Department of Environmental Protection

RE: Feasibility Study Report, Site 38, NAS Pensacola

Memorandum

SUBJECT: Feasibility Study Report, Site 38, NAS Pensacola,
Florida

Site 38 Soil Boring Summary- Building 71

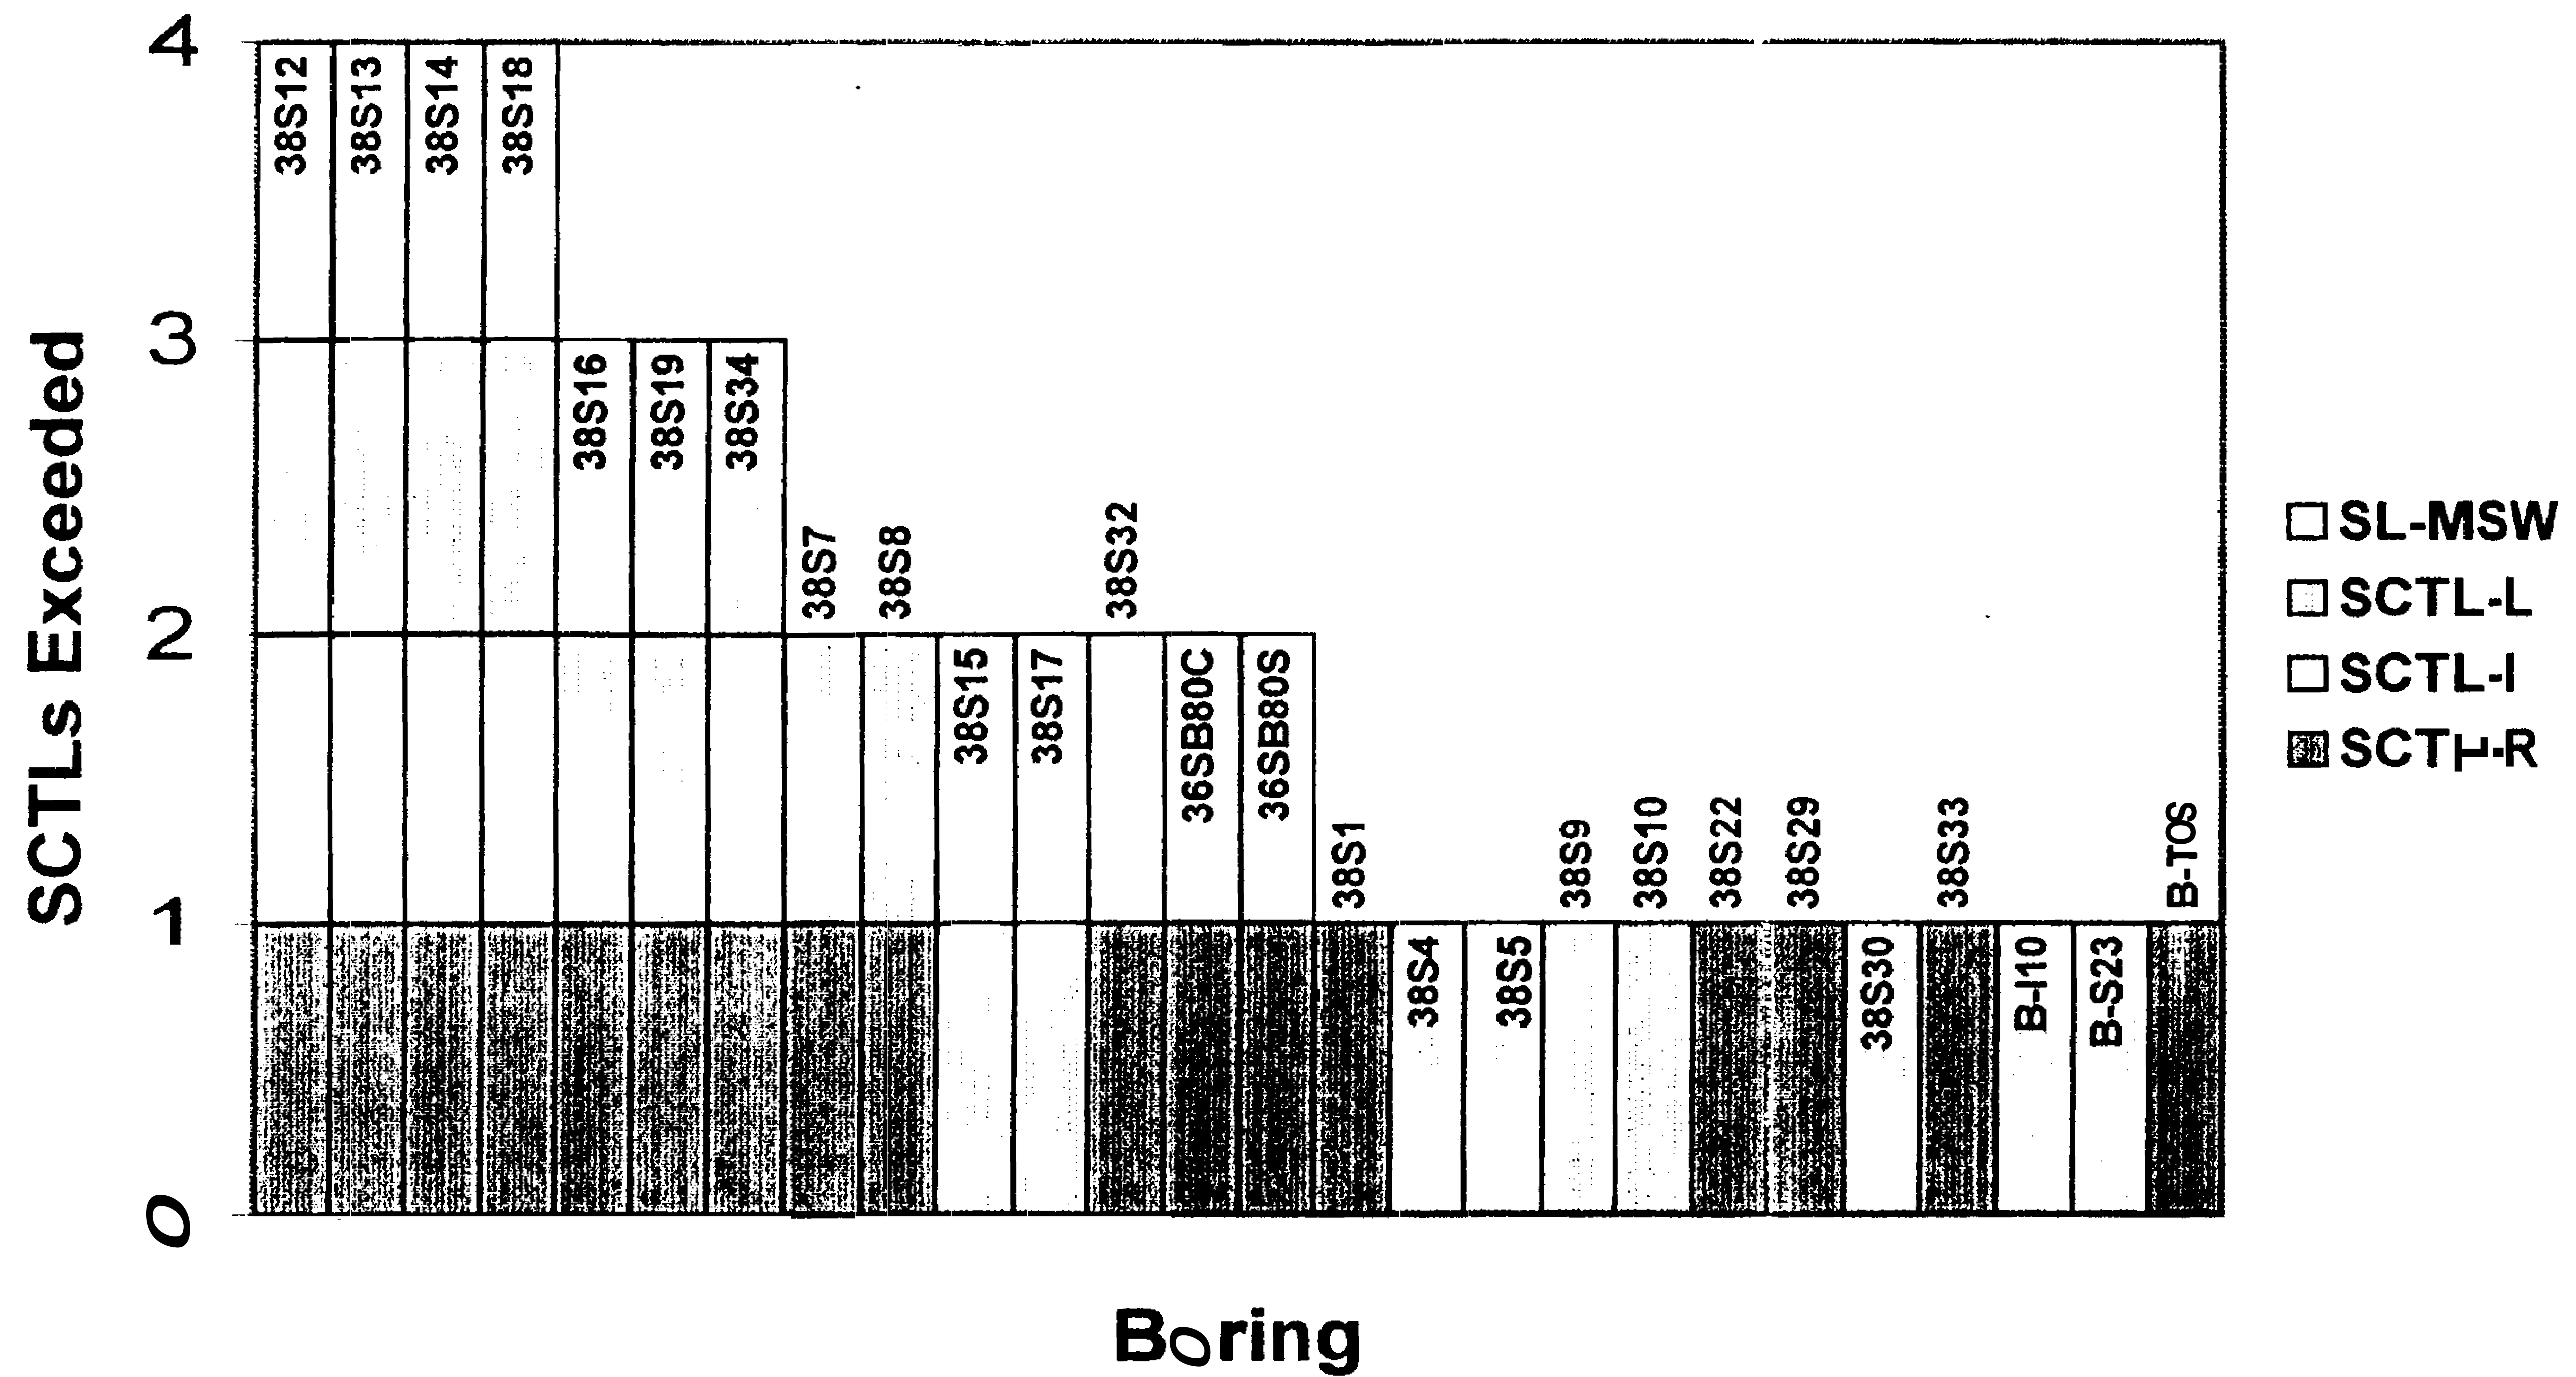
I ranked the reported Building 71 soil boring data assuming that the screening between appropriate soil cleanup target levels and analytical data was accurate in the feasibility study. The attached Pareto diagram summarizes the ranking results (I hope the diagram is self-explanatory upon inspection).

Borings with one or more exceedances of a SCTL are presented in the diagram. For example, boring 38S12 had one or more contaminant concentrations that exceeded the residential (red), industrial (yellow), groundwater leachability (red), and marine surface water leachability (blue) Soil Cleanup Target Levels (SCTLs). Boring B-T05 had one or more contaminant concentrations that only exceeded the residential SCTLs. Other borings are intermediate to these extremes and are sorted to show their relative contamination rankings as screened against SCTLs.

The need to consider alternatives that include general response actions for soil such as excavation, treatment, and disposal, as well as containment and institutional controls, is further reinforced at the next tier of response. Soil volumes represented by borings labeled in "green" in the diagram have contaminant concentrations that exceed leachability SCTLs (groundwater). Only a minority of locations remains with leachability concerns if adequate alternatives could be proposed to address contamination exceeding residential and industrial SCTLs. These remaining locations are represented by borings 38S16, 38S19, 38S7, 38S8, 38S15, 38S17, 38S9, and 38S10.

The table attached to the Pareto diagram summarizes the contaminants found in those soil borings that exceeded *One* or more SCTLs. Water quality data from nearby or downgradient monitoring wells are also listed in this table. TCE and chromium are both found above the SCTLs for leachability (groundwater). Lead is also found at concentrations above the residential SCTL and in groundwater samples. These data indicate that soil with exceedances above the leachability SCTL is a continuing source of contamination to groundwater. Given that Building 71 is reported **"capped"** with asphalt already, alternatives **that** depend solely on containment do not appear feasible based on site data. A broader range and *scope* of alternatives are thus necessary.

Site 38 Soil Boring Summary - Building 604

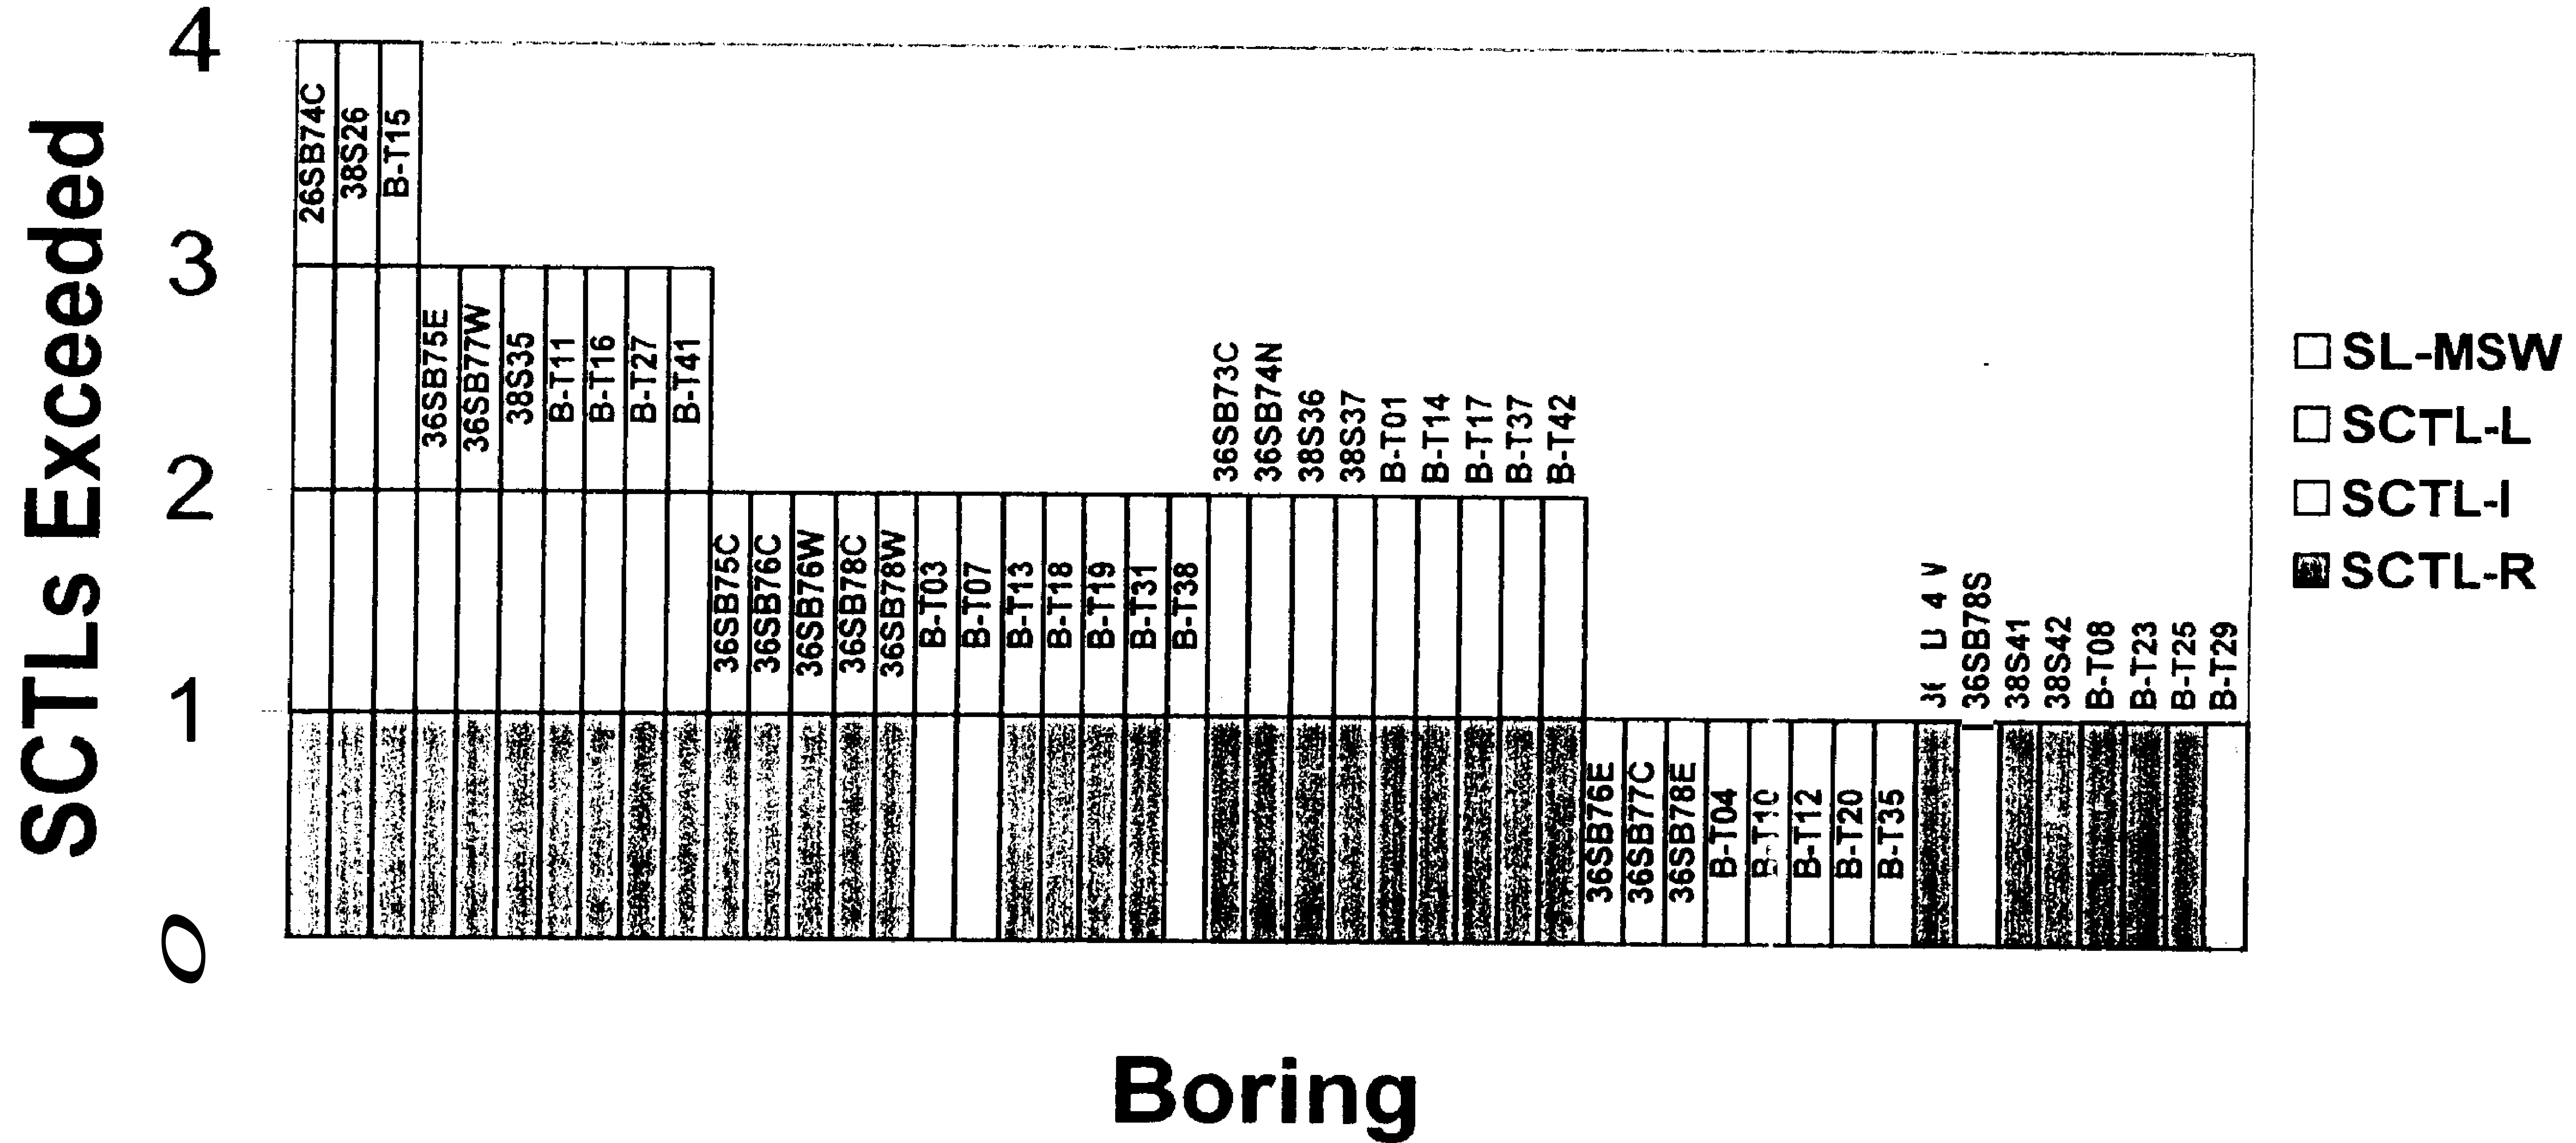
I conducted a similar analysis with the data from Building 604. Building 604 is a larger site and more complex. I am not able to analyze Building 604's data in depth because of time constraints from competing projects. Nonetheless, I obtain conclusions similar to Building 71. Focusing on soil contamination near monitoring wells 38GS07 and 38GS19, metal

contamination in both soil and groundwater is apparent (lead, cadmium, chromium). PAHs in soil and groundwater may also be of concern towards the southwest corner of Building 604. Again, alternatives that provide risk managers broader ranges and scopes of options should be formulated so that fully informed tradeoffs between protectiveness and cost-effectiveness can be judged.
